Belvac Production Machinery Technical Bulletin

ISSUE 03 VOL. 9 MARCH 2006

CC93 Trimmers Main Turret Starwheel Design

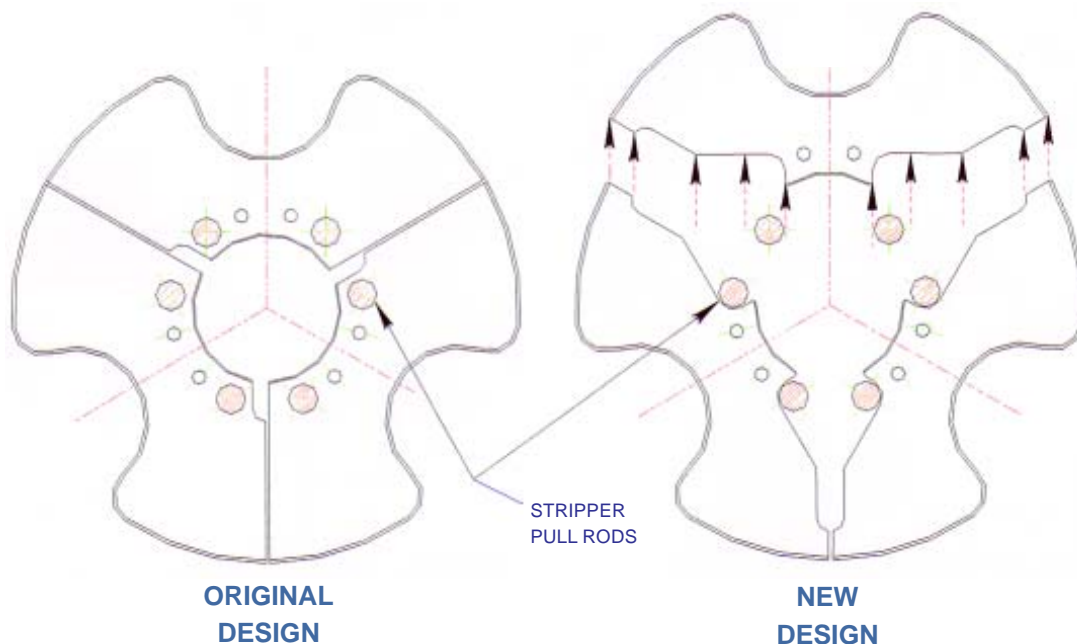
In March of 2004, Belvac redesigned the "CC" Trimmer main turret starwheel on the most common can sizes to accommodate ease of assembly and disassembly for our customers. The original design, shown below, requires the customer to disassemble the stripper pull rods from the spindle assembly in order to replace a starwheel segment.

The new design provides clearance cutouts allowing the starwheel segments to be readily removed without disassembly from the stripper pull rods.

As on the original design, the starwheel segment is bolted to the starwheel hub, and adjusted relative to the can chuck. The new design is fully interchangeable.

As this design is an enhancement to the machine, the original design style is no longer offered. The original part numbers have been maintained for ease of ordering.
